STAFF REPORT

PROJECT: Hill Pond Residences Project Development Plan, PDP #140015

APPLICANT: Catamount Properties
Charles Bailey
7302 Rozena Drive
Longmont, Colorado 80503

SITE PLAN

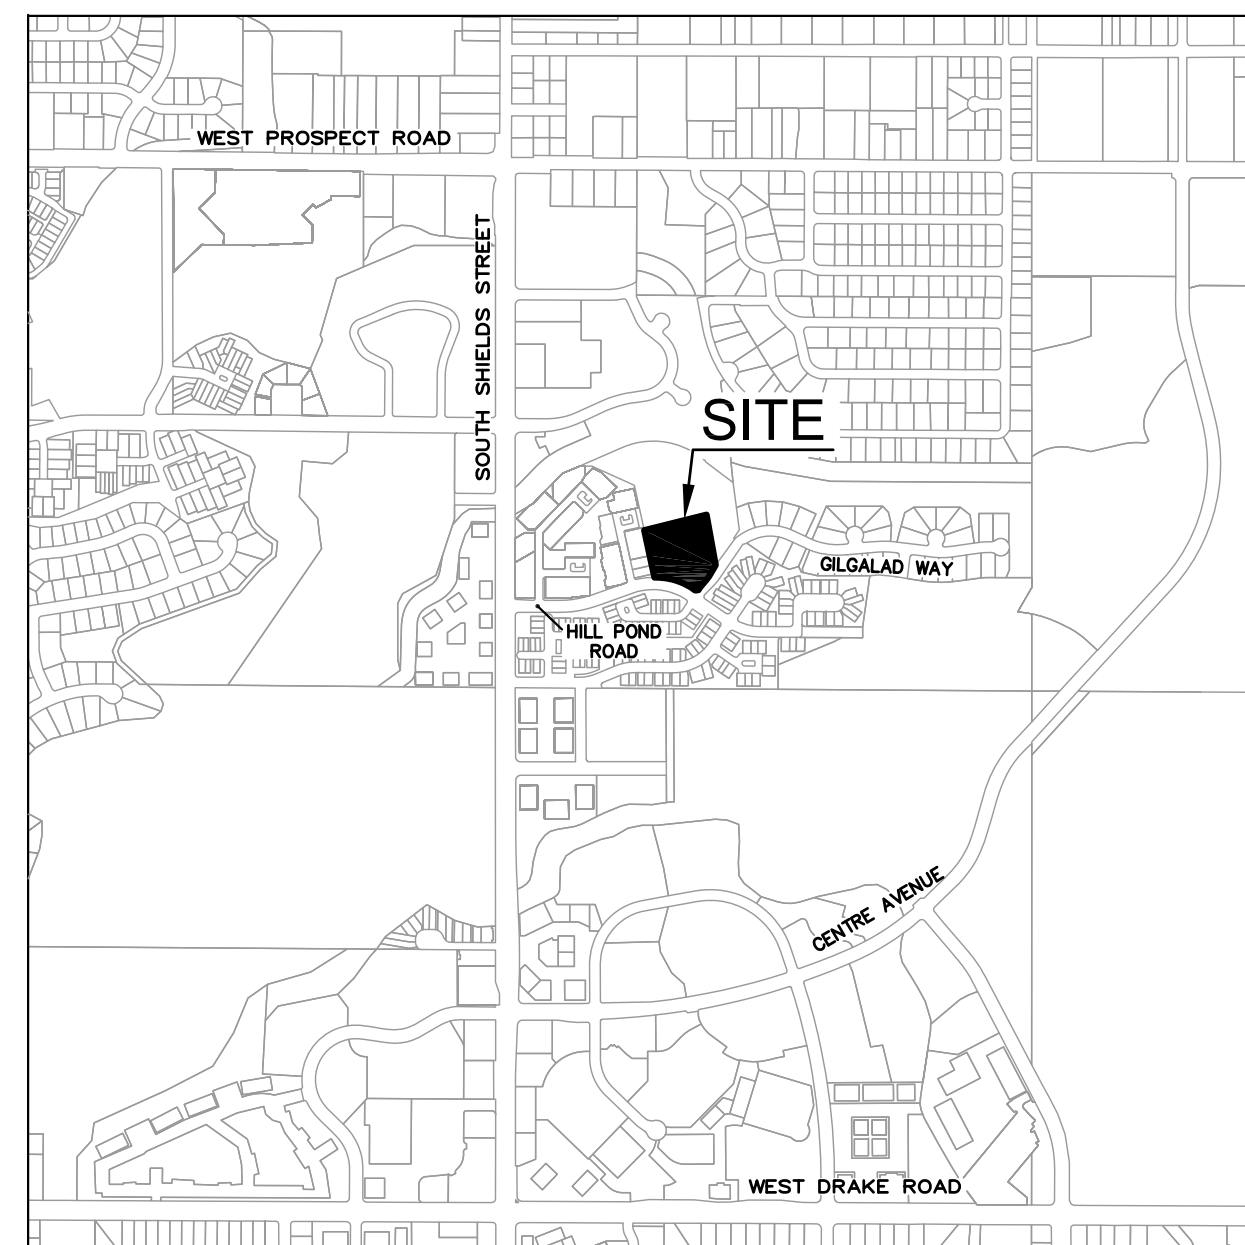
Lastly, in the southeast corner of the site, southeast of dwelling unit 1 (units are labeled on the site plan for reference), an additional shade tree would be beneficial. Staff is recommending that a Bur Oak proposed in the center of the site be moved to this location, and this will also provide for additional access in the center of the site for snow stockpiling in the lawn area.

- 6) Locations for on-site snow stockpiling should be considered.
 - One adjustment to the plans that staff can address should the project proceed to the final plan stage is moving one of the proposed bur oaks from the east side of the central lawn area to the southeast portion of the site. This will accommodate better access to the central lawn area for snow stockpiling.
